**RE: Response to NMOCD Comments Email, Dated 29 October 2024**  
**Myrtle Myra SWD #001 Well (API No. 30-015-21515) Site Assessment Plan**  
**2.24 Acres of Section 21, Township 21S, Range 27E, Subdivision NENW (and Assoc. ROW)**  
**Eddy County, New Mexico**  
**SQE PN: 1180.082.001**

**RESPONSE TO NMOCD COMMENTS, DATED 29 OCTOBER 2024**

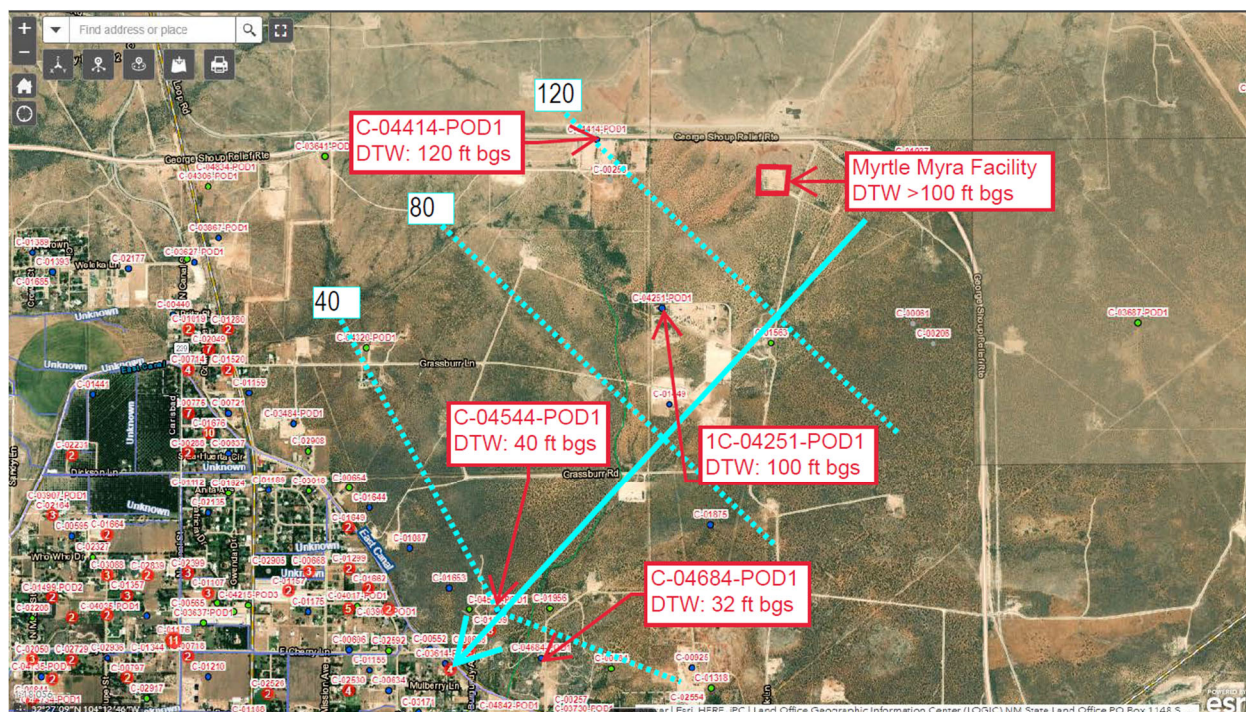
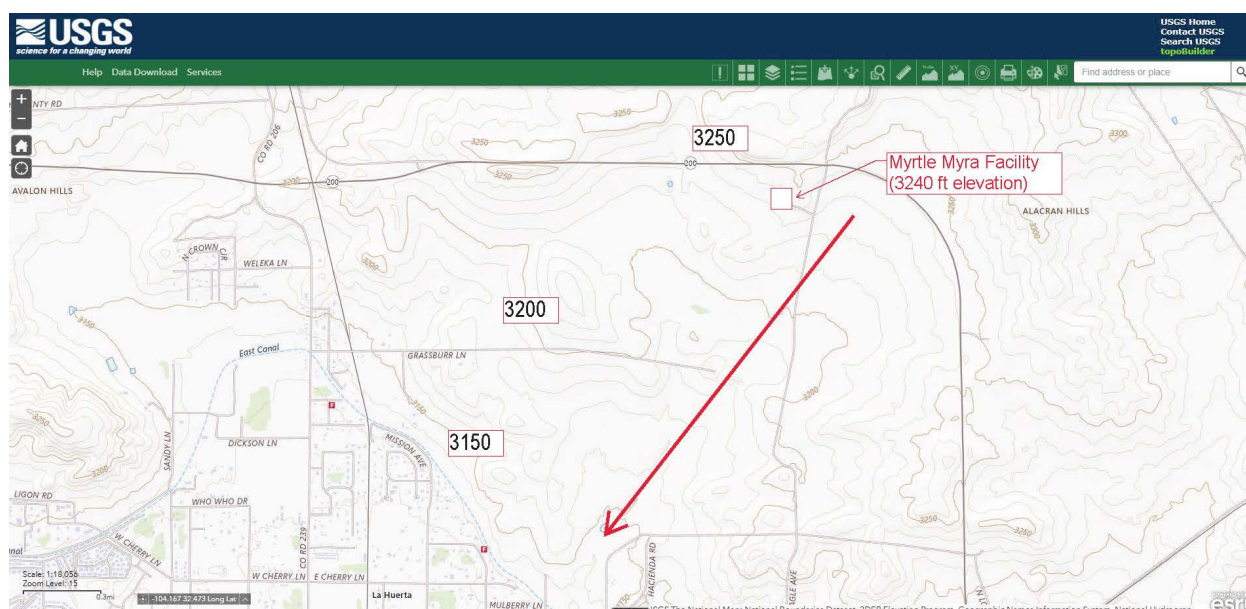
**Comment 1:** *If nearby wells are used to determine depth to groundwater, the wells should be no further than ½ mile away from the site, data must be no more than 25 years old, and well construction information must be provided. OSE-POD C-04251 is .5 miles away and has a depth to groundwater of exactly 100 feet, therefore Table 1 51 feet-100 feet RRALs apply. Pursuant to 19.15.29.11(A)5(c) NMAC, "if the release occurred outside of a lined containment area and is in an area where depth to ground water is greater than 50 feet and less than or equal to 100 feet, the responsible party must delineate the vertical extent of the release to the greater of 600 mg/kg chloride or background level, if the release is of an unknown quantity or results in greater than 200 barrels of unrecovered produced water."*

- DTW appears to be increasing (deepening) when moving northeast from the City of Carlsbad (where the Pecos River and East Canal are located) towards the Myrtle Myra Facility. See below image (basemap from New Mexico Office of State Engineer website). Wells between the Pecos River and East Canal generally have reported DTWs between 20 and 30 ft bgs. Wells just northeast of the East Canal in the direction of the Myrtle Myra appear to generally have reported DTWs between 30 and 40 ft bgs. For further evidence of this, well C-04544-POD1 and C-04684 were selected as case studies. Well C-04544-POD1 was drilled in 2021 (3 years ago) and reported with a DTW of 40 ft bgs. Well C-04684-POD1 was drilled in 2023 (1 year ago) and reported with a DTW of 32 ft bgs.

A figure showing the general locations of wells described in this bullet, along with a simplified groundwater elevation map is provided below. Groundwater elevations appear to decrease (shallow) when moving southwest from the Myrtle Myra Facility towards the City of Carlsbad East Canal.

Additionally, the above observations are consistent with the topographic profile of the region. As shown in the below figure (basemap from the USGS website), land elevations (relative to sea level) appear to decrease when moving southwest from the Myrtle Myra Facility towards the City of Carlsbad East Canal.

Based on these data provided, the depth to groundwater at the Myrtle Myra is believed to be greater than 100 ft. A conservative estimate for current DTW at the Myrtle Myra Facility would likely be 120 to 130 ft bgs, based on the trends and information described above. Based on this evaluation, we respectfully request to use the NMOCD Limits that are respective for this groundwater depth (greater than 100 ft), as

**FIGURE 3 (REVISED)**

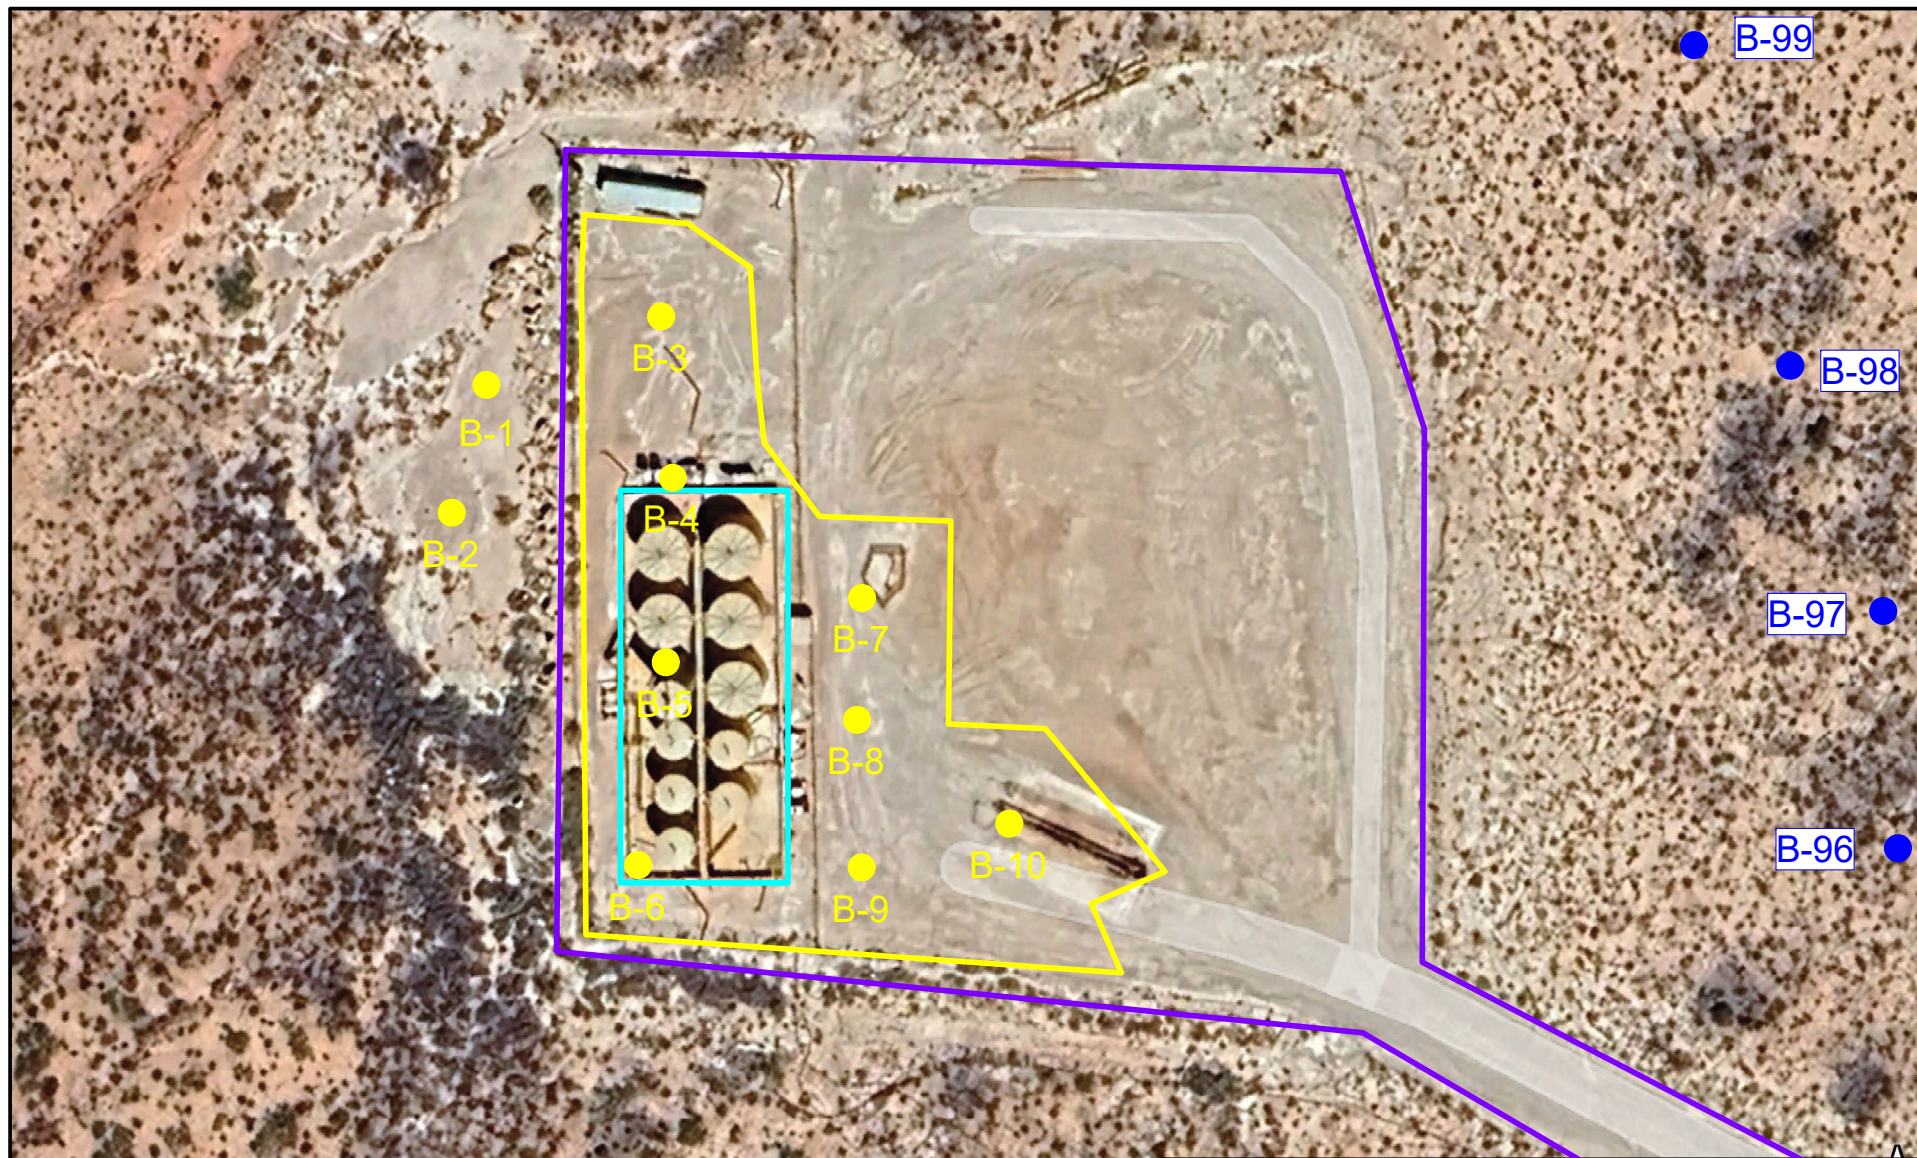
**Comment 3:** *It is noted that the Area of Impact shown on pg. 4, Figure B is larger than the area of impact that is drawn on Figure 3. Referring to Figure B, the ruler box located to the left of the yellow polygon is covering more impacts. It appears the berm was breached as there are scraping striations seen off pad on the west side that are similar to the scrapes on pad. This area will also require delineation. OCD will email a kmz file or a screenshot providing suggested sampling locations as the 3 provided in this Site Assessment Plan are not enough to delineate such a large release area.*

**Comment 4:** *The proposed background sample locations are not acceptable. It looks like you may need to collect them greater than 100 feet off pad (which is completely acceptable in this situation), well away from any disturbed areas, and upgradient. They must be tested for all Table 1 constituents as well. Submit remediation plan to OCD by 1/27/2025.*

1. 19.15.29.11(A)5(c) NMAC does not apply based on depth to groundwater information.
2. Due to the historical nature of this release, all delineation samples collected must be submitted to a laboratory for analysis.
3. The amount of delineation samples collected is not up for debate. Based on the Google Earth imagery the day after the release occurred, the release area spread further east on the pad than your proposed delineation sampling locations cover. OCD wants all locations identified to be sampled.
4. The background chloride locations need to be both upgradient and higher elevation than the pad itself. The proposed locations of B-98 and B-99 are less than or equal in elevation to the pad itself and as such those areas are not acceptable.

Based on the ~41,000 square foot (ft<sup>2</sup>) area of impacts, this is a requested sampling density of one sample per approximately 3,000 ft<sup>2</sup> (or one sample per 0.07 acres) on the well pad. SQE is amenable to collecting additional samples to identify constituents at levels above Table 1 closure criteria; however, we propose a sampling density of one sample per approximately 5,000 ft<sup>2</sup> (or one sample per 0.11 acres) on the well pad (eight samples). SQE agrees with the plan to collect two samples to the west side of the pad in the area where NMOCD suggested the berm may have been breached. In total, SQE proposes ten sampling locations for identifying constituents at levels above Table 1 closure criteria, as shown by the revised **Figure 3** attached to this letter.

Response to Comment 4: SQE concurs with Comment 4. Revised background sample locations are proposed on the revised **Figure 3** attached to this letter. Background samples will be tested for total petroleum hydrocarbons (TPH), BTEX constituents (benzene, toluene, ethylbenzene, and xylenes), and chloride using the analytical methods presented in Table 1.
